TECHNICAL BULLETIN

Author: Bill Detherage	Bulletin # SB-1014
Verification: Alex Kim	Date Issued: 11/21/2012
Product: HA45 & HA50	Date Revised:

Subject:
HA45 and HA50 Door Motor Wire Termination

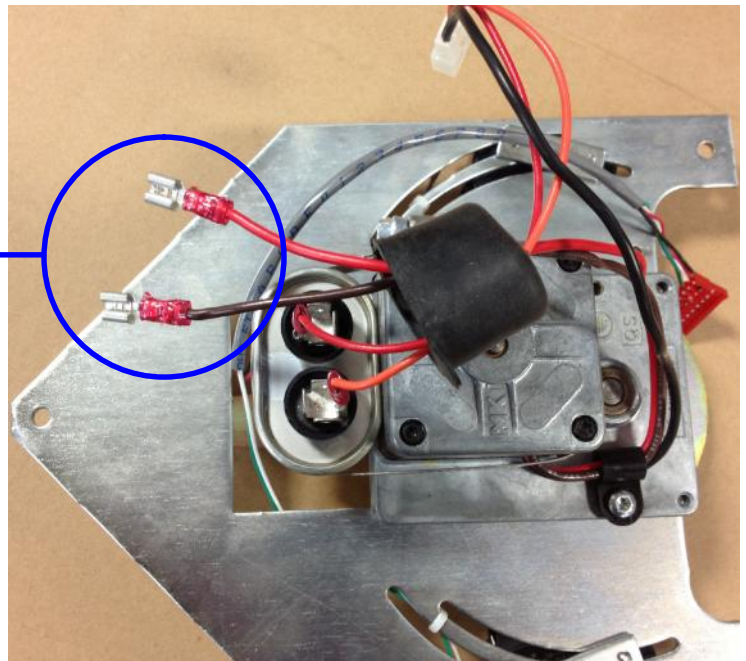
The HA45 and HA50 customer unit door motor terminations have been found in some units to not be making the proper connection between the wires and connectors. These small red connectors are crimped onto the door motor wires. It was found during manufacturing that the tool used was faulty, therefore not making the proper crimping action to properly connect onto the wires.

If the unit is being serviced for any reason, we are recommending the two door motor wire terminations be checked and crimped again to make sure proper connection is made between the connector and the wire. These connectors are located on the door motor red and brown wires that are attached to the capacitor.

Crimp connectors to ensure proper connection to the door motor red and brown wires. The wires are shown disconnected from capacitor.
